# **EPA Superfund Record of Decision:**

**Land and Gas Reclamation  
Landfill Site, Williamstown, WI  
1/13/1994**

### SOURCE CONTROL OPERABLE UNIT INTERIM REMEDY

Figure A

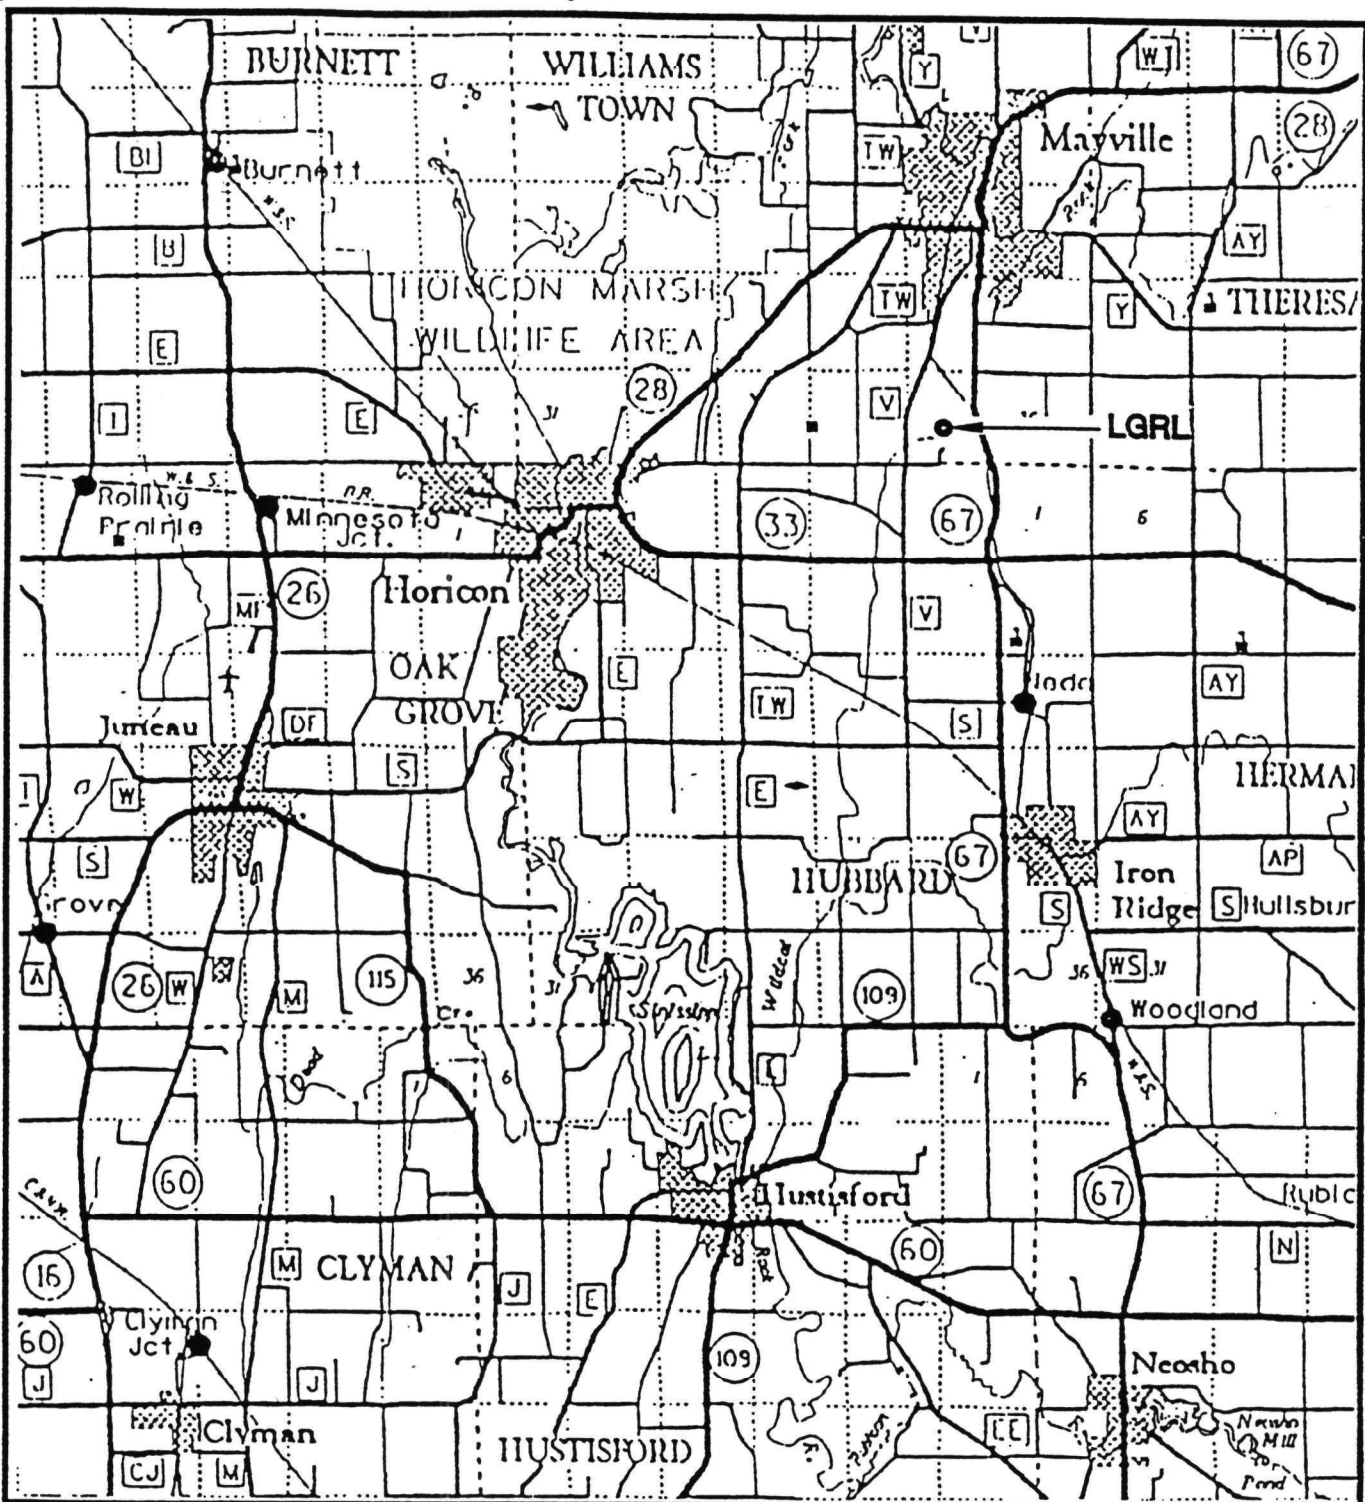
A site map should be included in Section I. (U.S. EPA, Reg. 5)

This change has been made.
